Re: 2059 NW O'Brien Rd
Lot 182, The Estates of Woodridge
Lee's Summit, MO
Permit # PRRES20222990

Apex Engineers Inc. observed the house under construction at the above-referenced address. Our firm has been retained to address comments from the city rough-in inspection. For the purposes of this report, the house will be referred to as facing north.

Figure 1.0 – Basement Plan

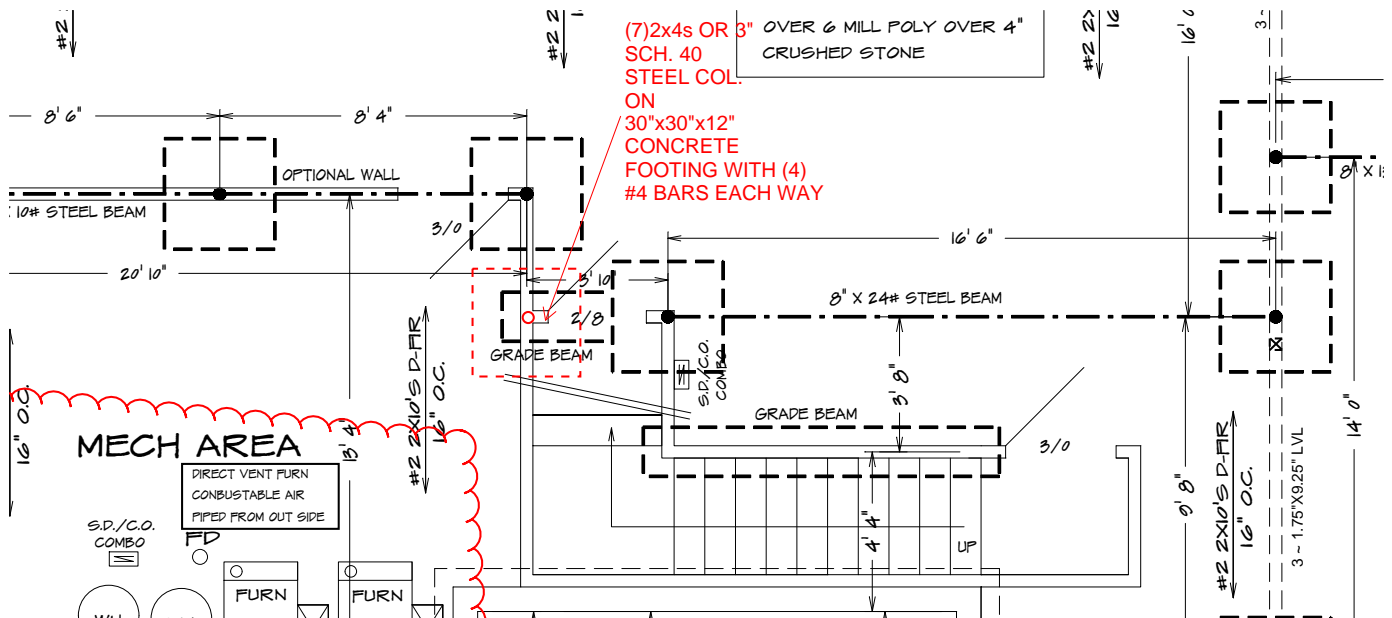
4. *Address/clarify (3) 2x4s used instead of column shown on plans resting directly on the beam below by stairs.*
 - Min (7) 2x4 built-up wood studs** or 3" (3.5' O.D) shall be installed to support the steel beam at the main floor stairs, above and below the flush beam in the floor. The column in the basement shall bear on a minimum of 30"x30"x12" concrete pad with #4 bars each way (contractor to verify condition).
